# TECHNICAL BULLETIN

## Automatic Transmission – Defaults To “Limp Home” in Wet Weather – Repair Procedure MODEL Sedan Range (4.0L) up to 93 MYDATE 1/95

44-24

ILLUSTRATION 1

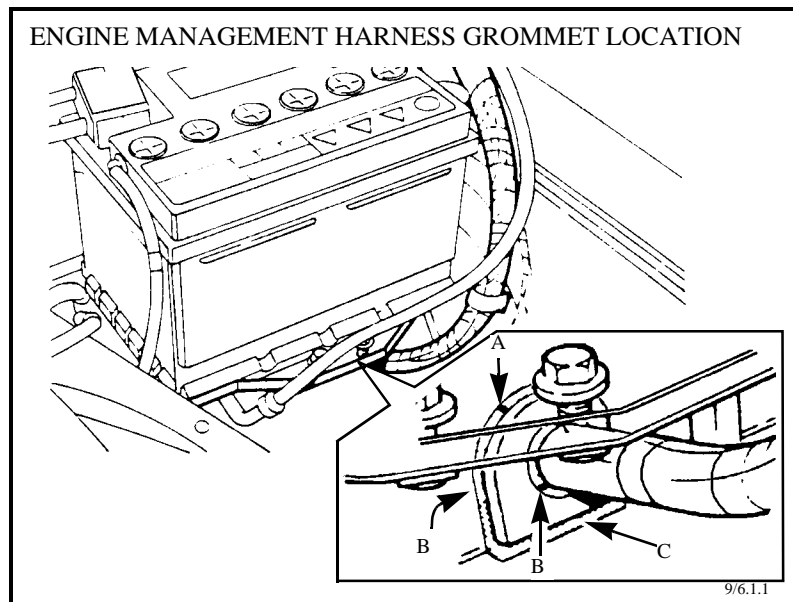
The Transmission Failure malfunction indicator lamp (MIL) illuminates and the transmission defaults to the “Limp Home” mode during rain or after using a car wash.

Water can enter the vehicle through the engine management harness grommet in the vacuum tank under the battery tray. The water can drip onto the Transmission Control Module (TCM) causing it to illuminate the transmission MIL and default to the “Limp Home” mode.

1. Record the preset radio stations (including X-mem) and remove the battery from the vehicle.
2. Remove the battery tray, disconnect the EMS harness from the vacuum tank and remove the vacuum tank
3. Inject a liberal amount of Bostik Alpha Seal 132 or an equivalent sealant into the areas shown in Illustration 1.

A. - Around the vacuum tank inner recess for the grommet.

B. - Around the EMS harness at the front and back of the grommet

C. - Between the EMS harness grommet and the body panel face
